December 9, 2022

SOLICITATION ADDENDUM NO. 1
ITB 22-0018
Classroom Walls- Phase 3

DRAWING REVISIONS

ENLARGED FLOOR PLAN #1

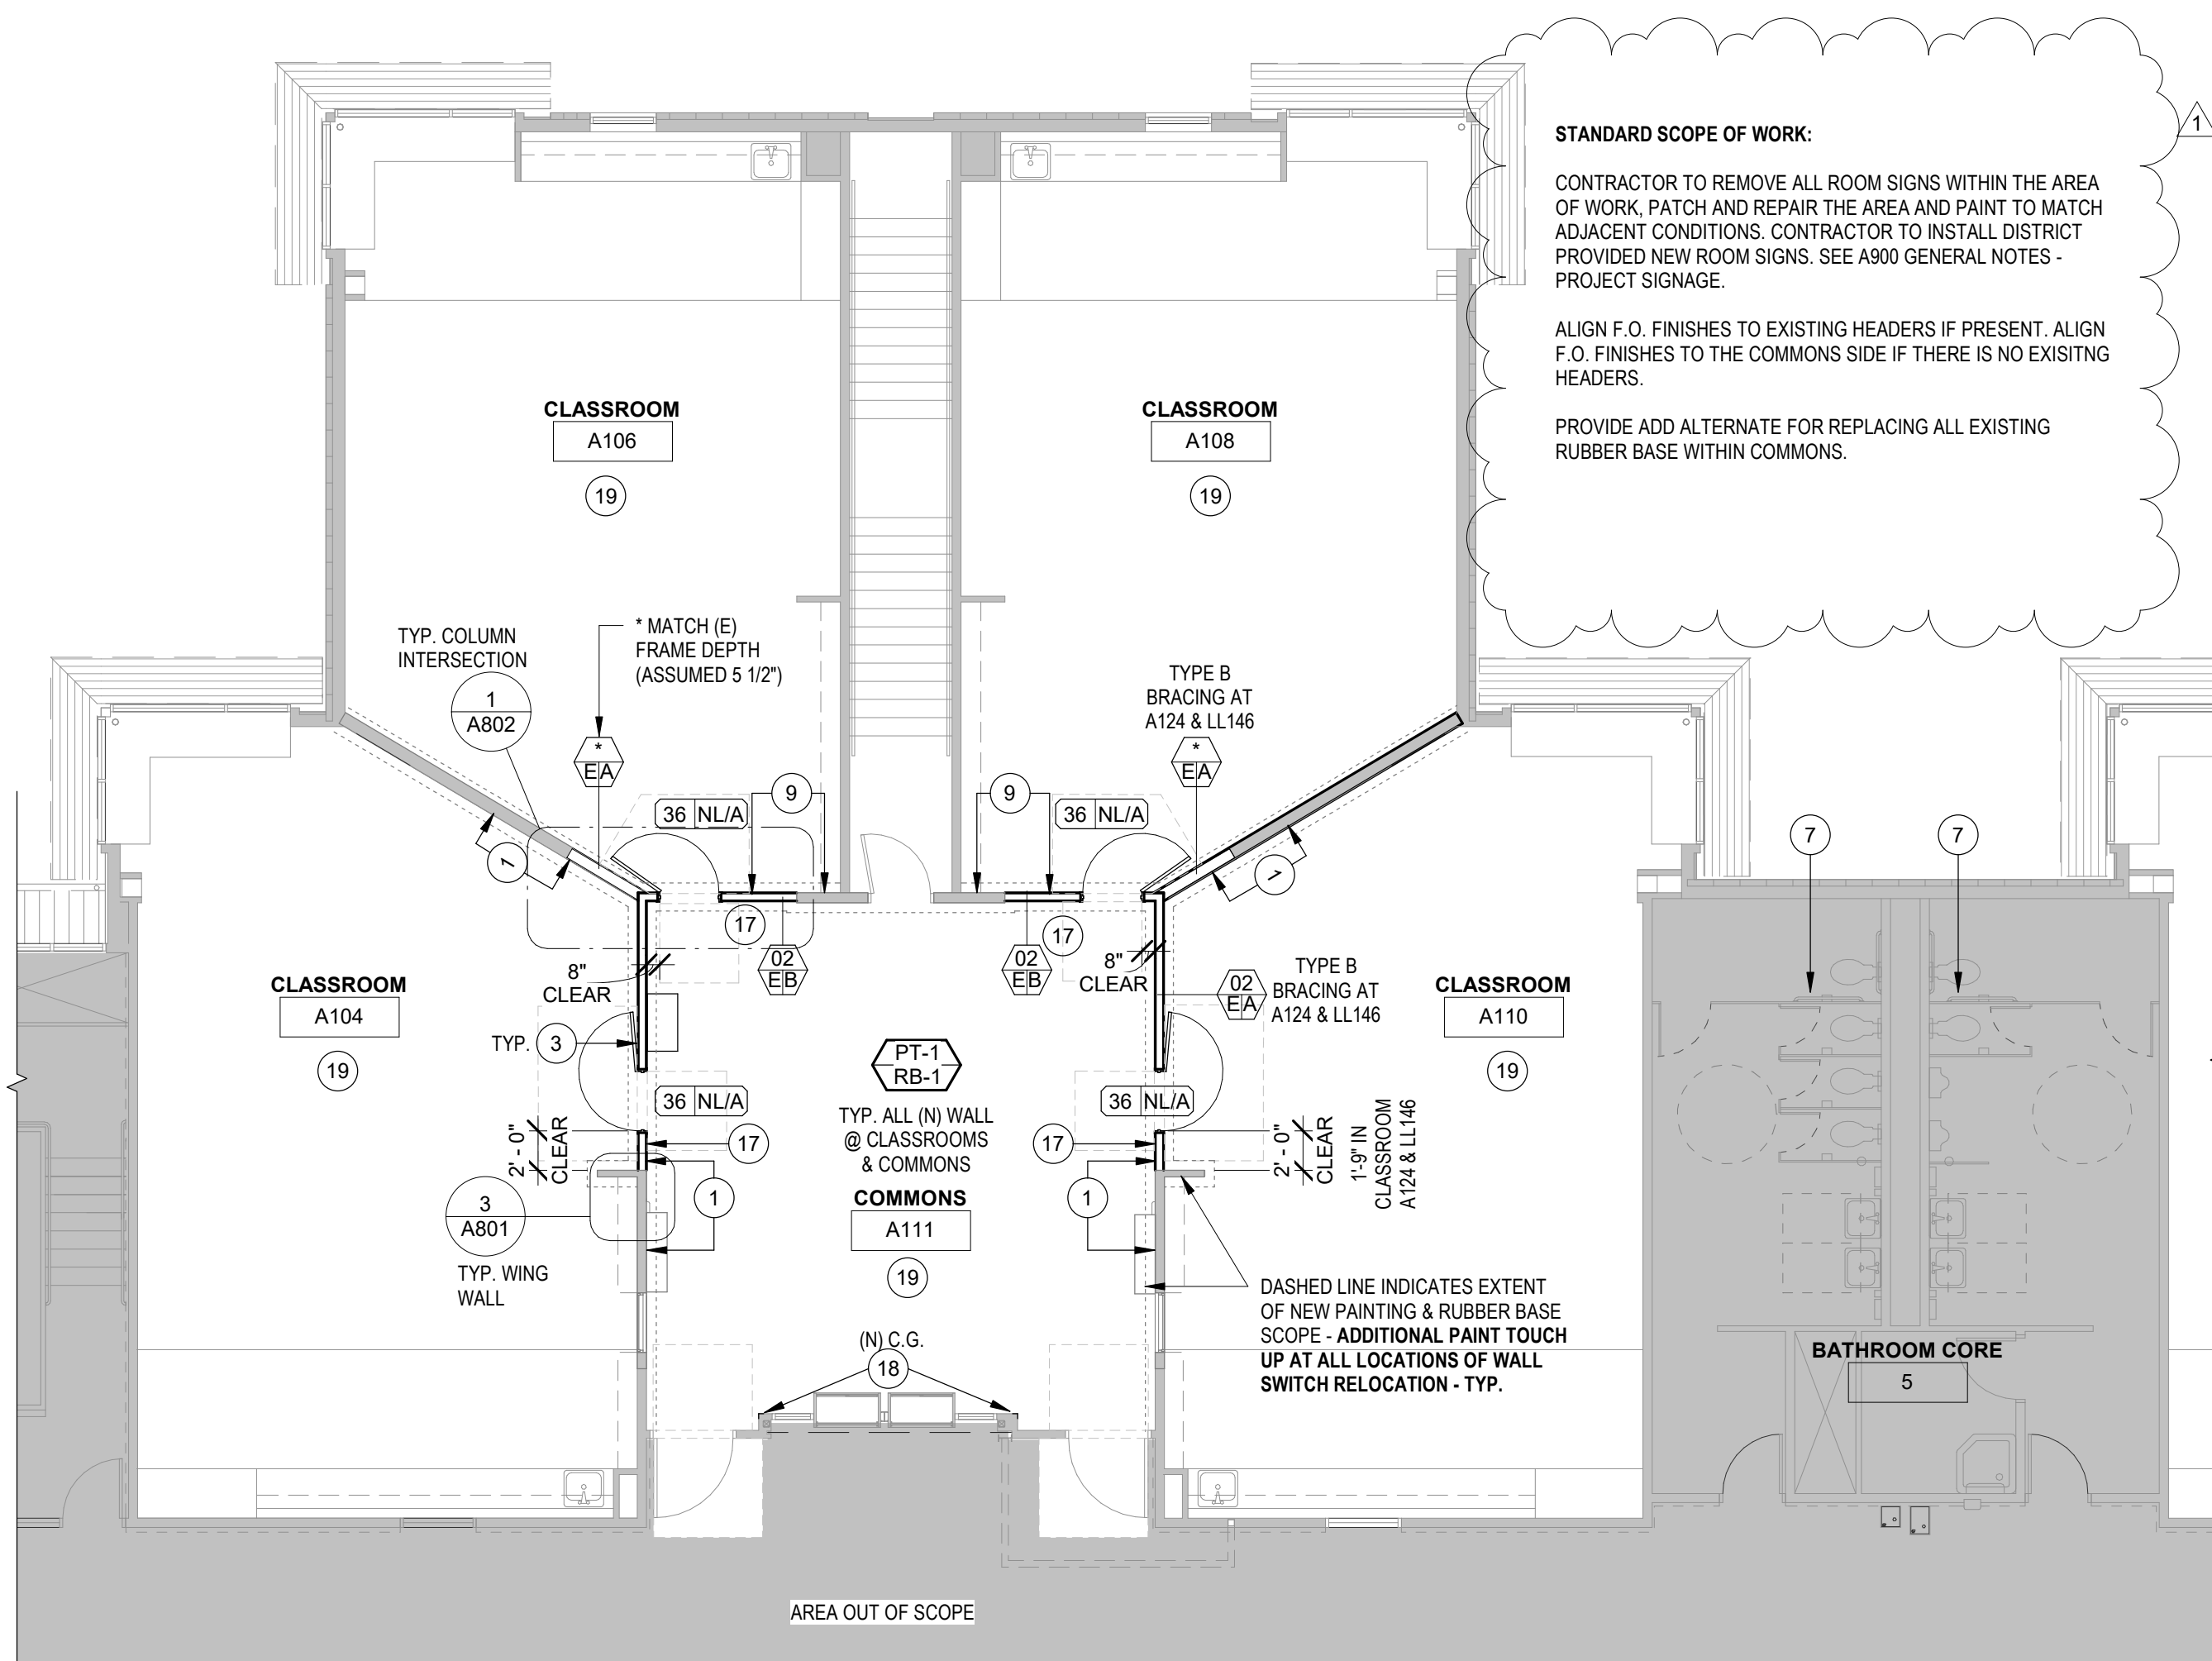
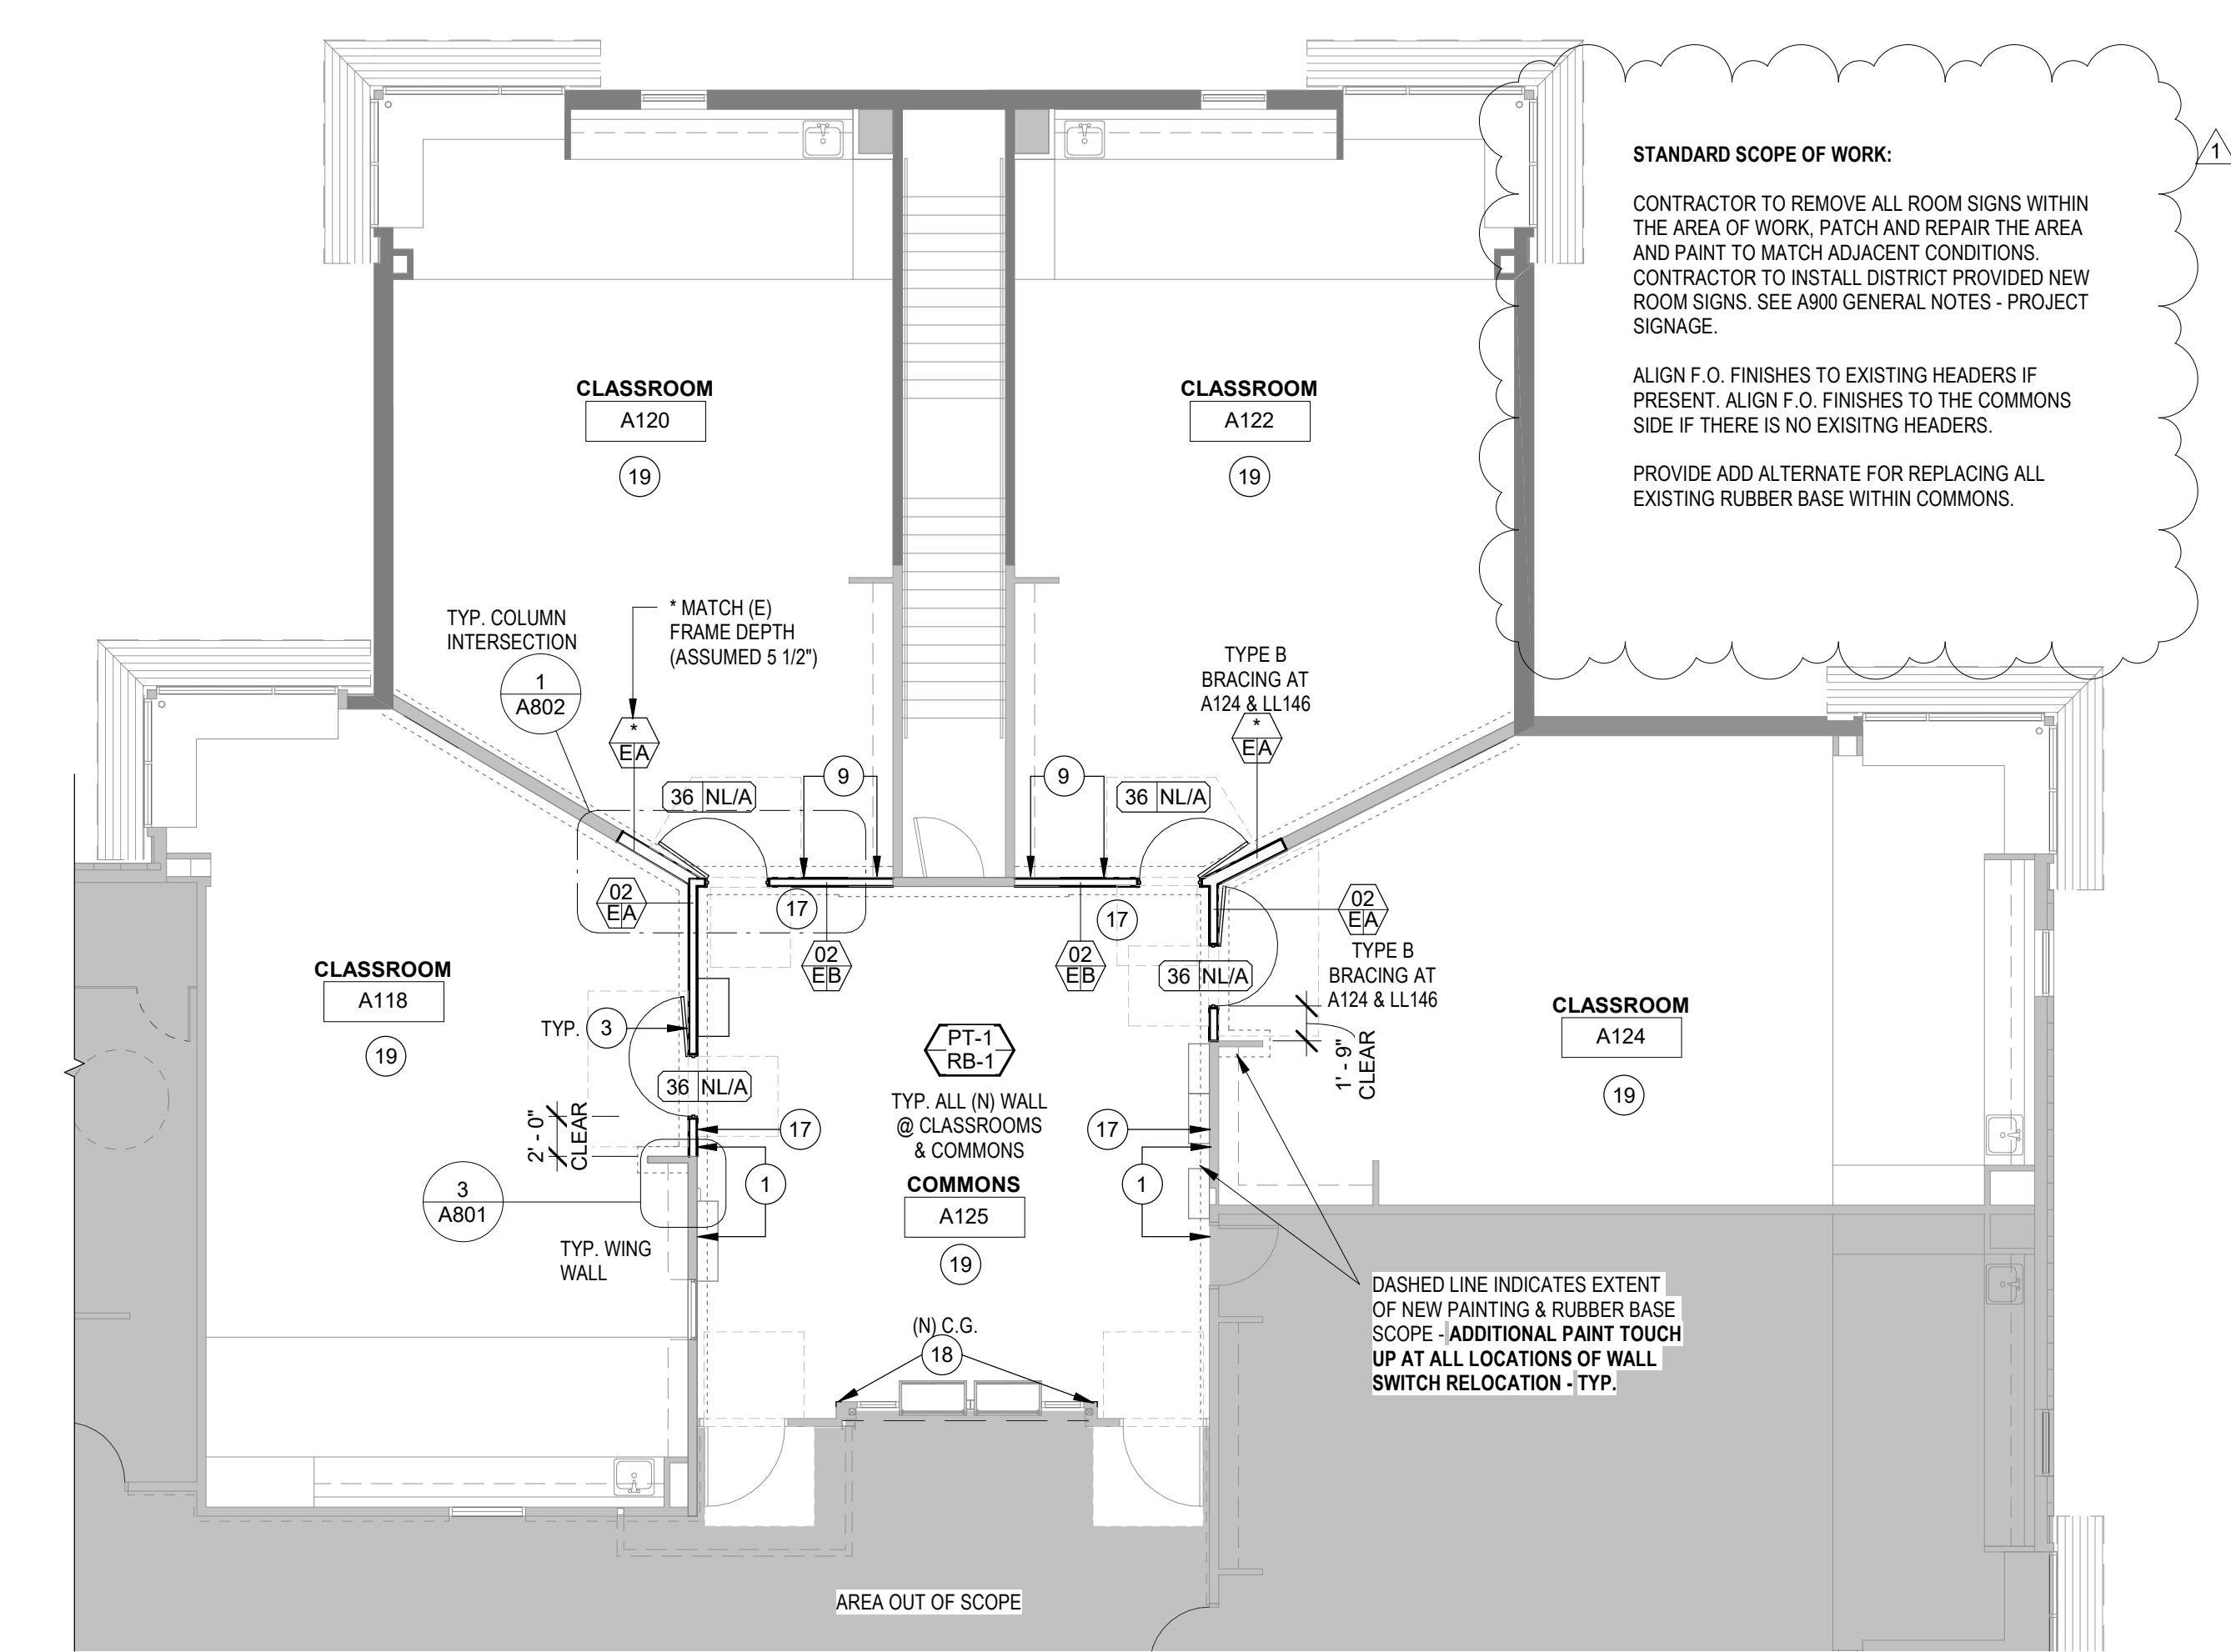
- 1. A113 - ENLARGED FLOOR PLAN:
 - a. **Enlarged Plan** - Standard Scope of Work note is added following clarification from bidding questions.
 - b. **Updated Room Numbers** - Room numbers are updated to match the existing numbering system. This item is for coordination and information only, no scope revisions are anticipated from this change.

- c. **Finish Schedule** - Paint color and rubber base specifications have been updated to the best of the architect's knowledge. Contractor to color match and provide paint drawdowns. An add alternate is called for the rubber base replacement scope.

FLOOR PLAN - MAIN LEVEL - ELECTRICAL
1/16" = 1'-0" 1

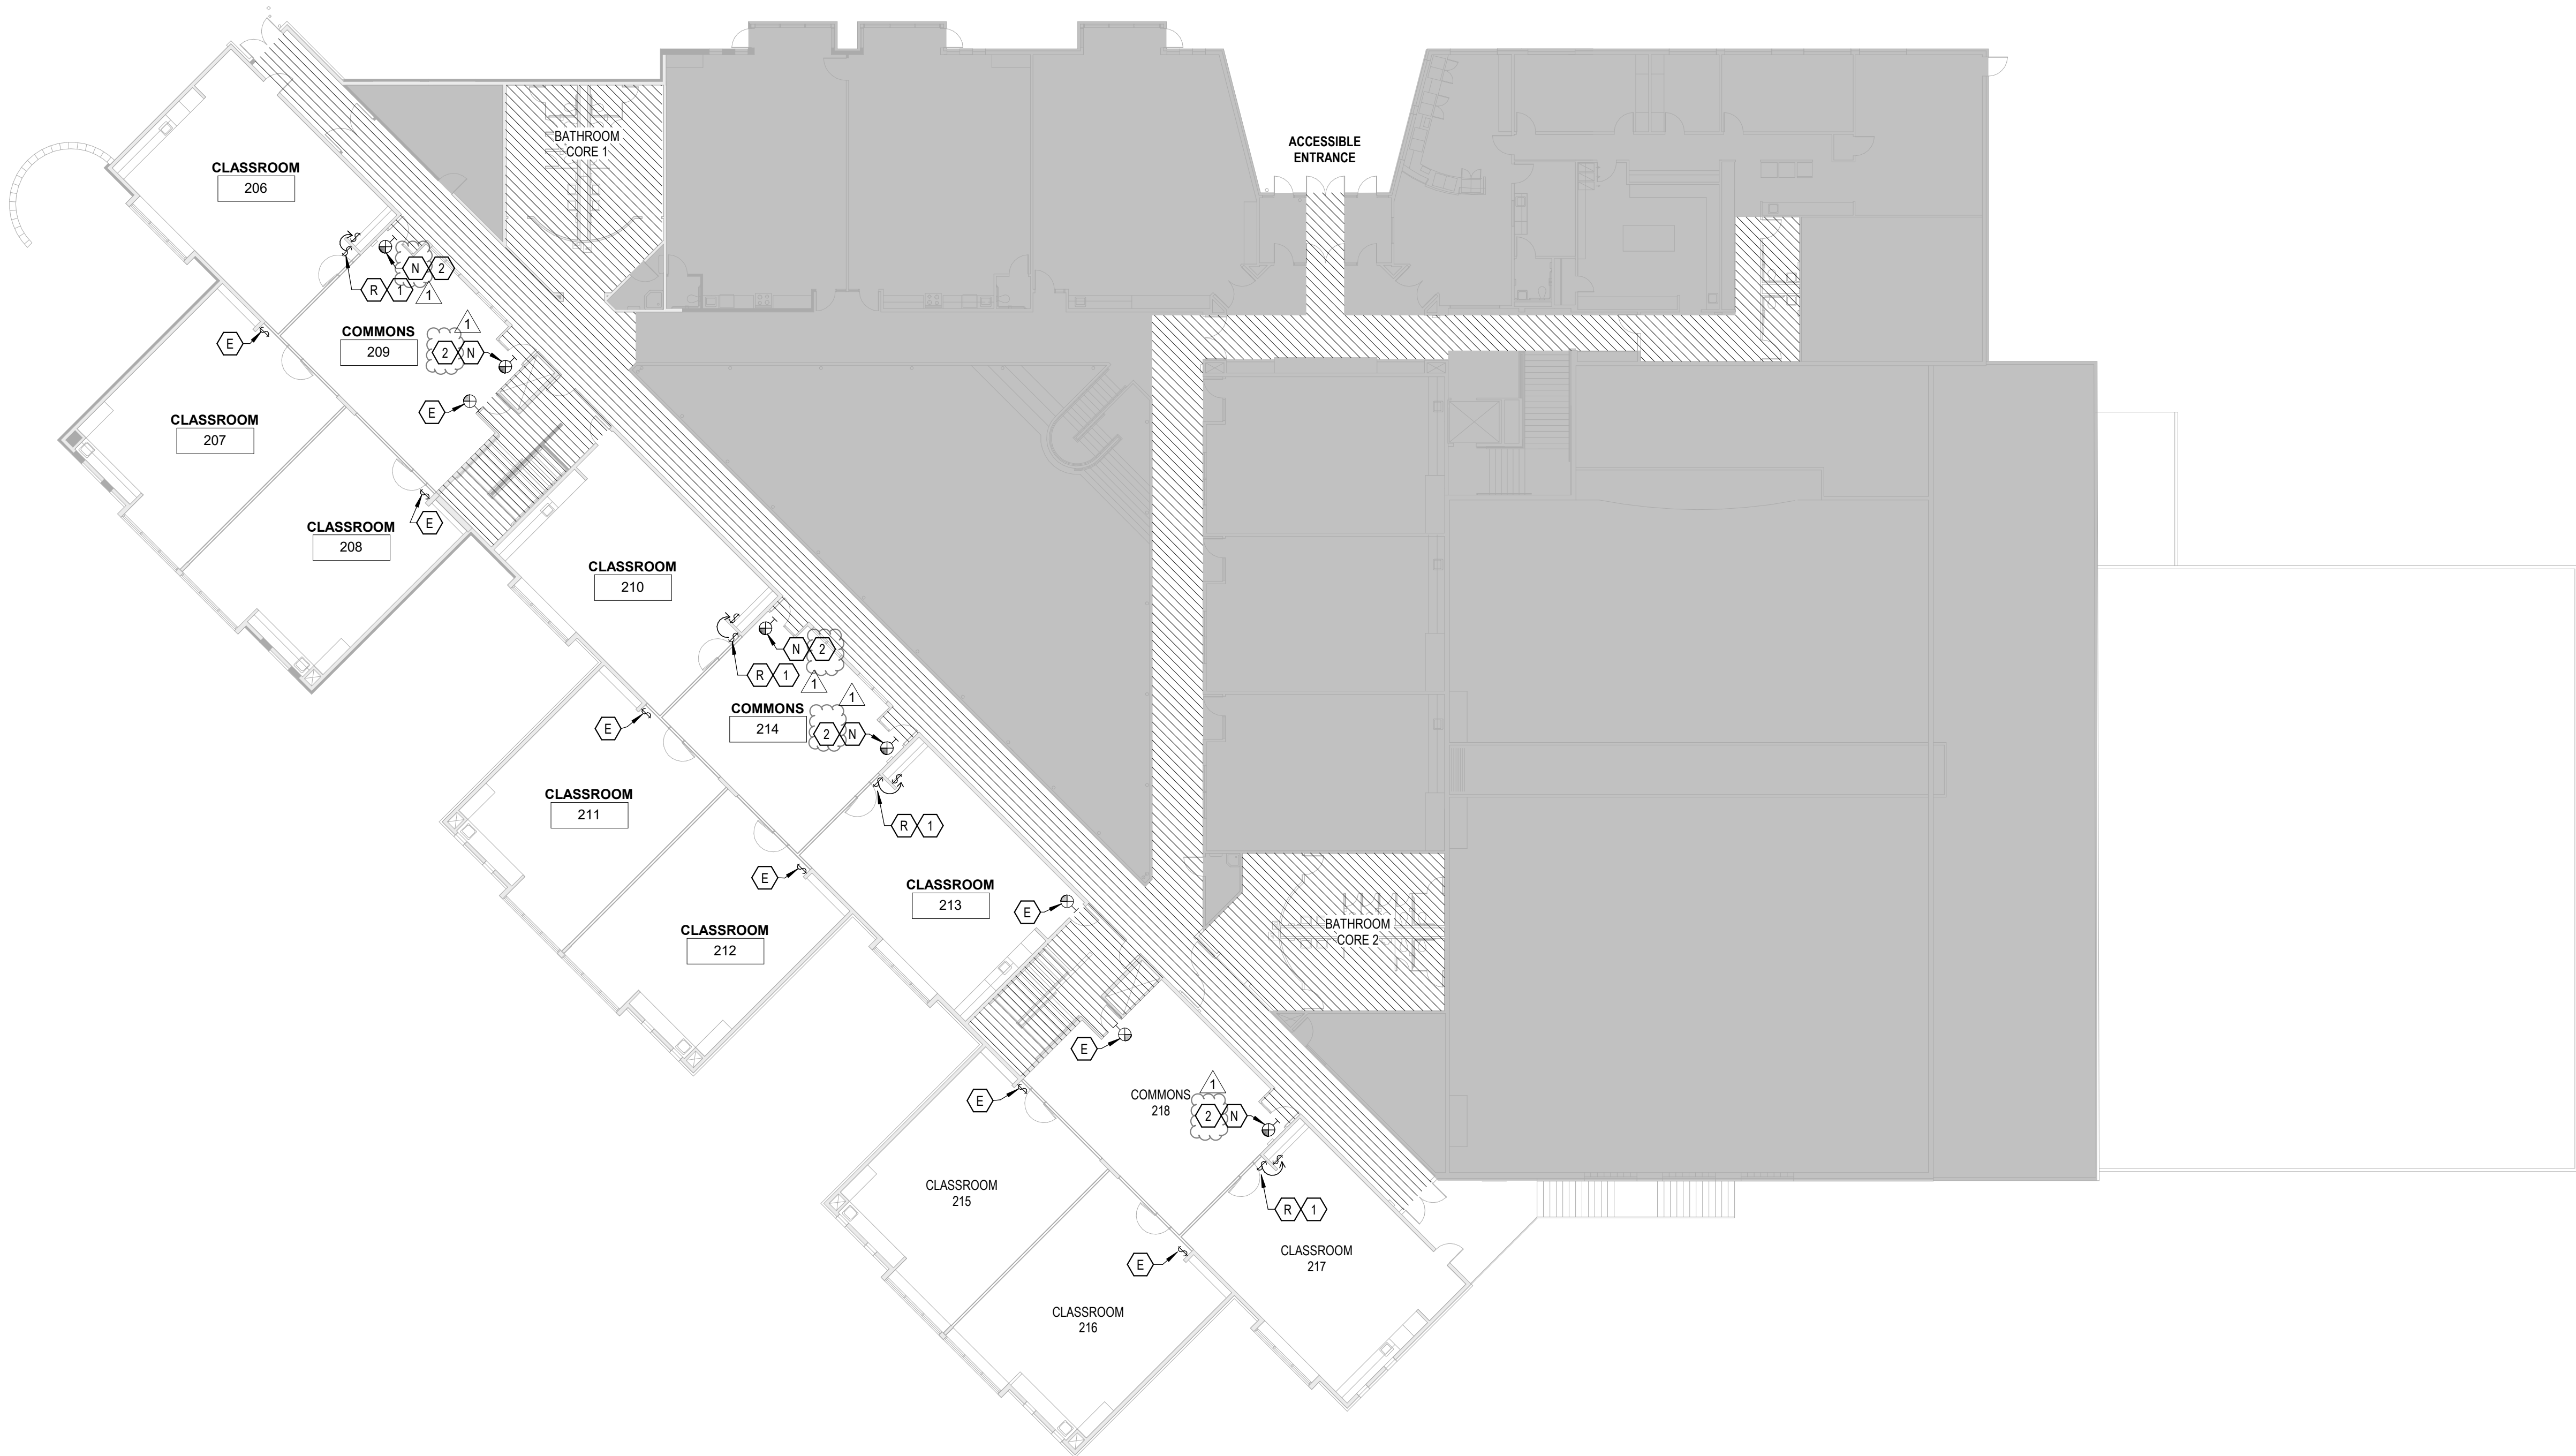
1. E111 & E112 - FLOOR PLAN - MAIN LEVEL ELECTRICAL / LOWER LEVEL ELECTRICAL
 - a. See keyed note 2 and clouded areas within the plans on these pages to show new exit signs and installation locations. Product specification included within the keynote.
